Event # 44896

PART 21 NOTIFICATION - DEFECTIVE HK AND K-LINE CIRCUIT BREAKER TENSION SPRINGS

Subject: Amended Report -- 10 C.F.R. Part 21 Notification of Deviation re. P/N 716539A00 Tension Springs

HK Racking Mechanism Latch

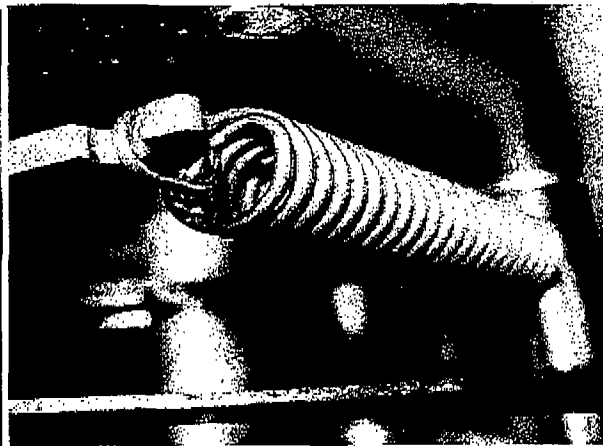
The identification of the Subject component is as follows: ABB P/N 716359A00 Tension Spring. These springs are used in both HK (Medium Voltage) and K-Line (Low Voltage) circuit breakers. In the HK breaker, the spring is used on the racking mechanism to position the racking mechanism interlock latch. In the K-Line circuit breaker, the spring resets the prop latch mechanism following a circuit breaker trip. See photos below:

Nature of the deviation: Micro-cracks in the base of the hooked end of the springs may result in failure of the springs after repetitive cycles. A broken spring could potentially affect the ability of a K-Line or HK breaker to reset and close after an opening operation. Initial report of the nonconformance was generated 2/11/2009 (NCR #68999JL), reporting springs failed during mechanical life testing being performed on a K-Line Breaker. Three springs failed after approximately 2800 cycles each.

Metallurgical analysis of a failed spring concluded that the failure originated in pre-existing cracks in the bend area at the base of the fully formed round hook. Subsequent investigation at the vendor site determined that a production run in April 2008 was manufactured using a different method than prior production runs, in that the fully formed round end of the spring was made using a manual press instead of an automatic hydraulic/pneumatic press. The manual press forming cycle was significantly faster, in that the loop was formed in approximately one second, versus six seconds for the automatic press. Additionally, the manual forming operation was done after tempering and stress-relieving the spring, while the automatic forming occurred prior to tempering and stress relief.

- c. Worked with our vendor, Ace Wire, to determine how future incidents can be prevented and developed quality assurance means to minimize the possibility of a recurrence. As of March 9, 2009, tooling has been polished to minimize tooling marks, and the fully formed hook will be made using the automatic forming machine on future orders.

- d. A cycle test has been completed to compare springs produced before and after Ace Wire polished the hook forming tools to validate that the corrective actions are sufficient. To date, 12,000 cycles on (20) springs have been completed, with no further failures. Microscopic inspection has also been done that confirmed the tooling marks have been reduced.

Given the large number of applications for the affected circuit breakers, ABB (Medium Voltage Service) cannot determine if the potential for a substantial safety hazard exists at any licensee's facility if a similar failure of the tension spring occurs. Licensees are requested to evaluate the history of inspections, maintenance practices, and circuit breaker operating cycles for K-Line breakers, and racking cycles for HK breakers to determine if the circuit breaker spring should be replaced immediately or at the next convenient maintenance opportunity. ABB recommends that any suspect spring with greater than 1400 operating cycles be replaced as soon as possible.

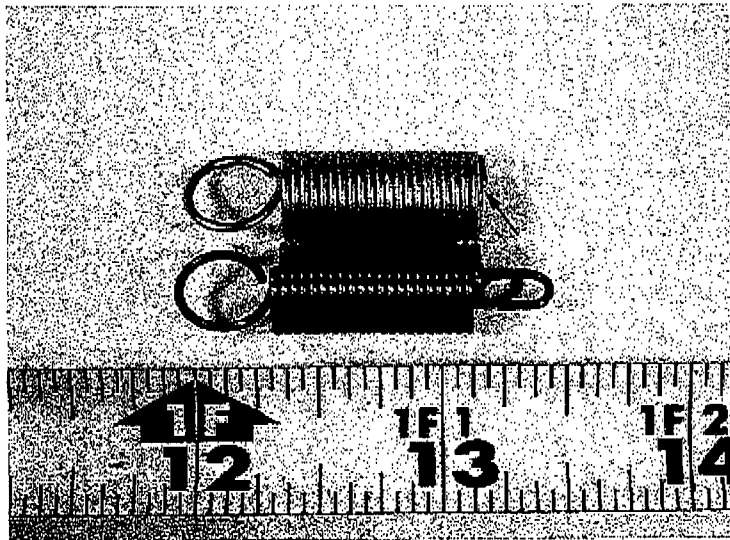
An additional issue was identified during the investigation in that the opposite end rectangular hook had tool marks from the forming operation that could result in premature spring failure. One spring failed after 6000 cycles in the concave bend area at this end. See photo below:
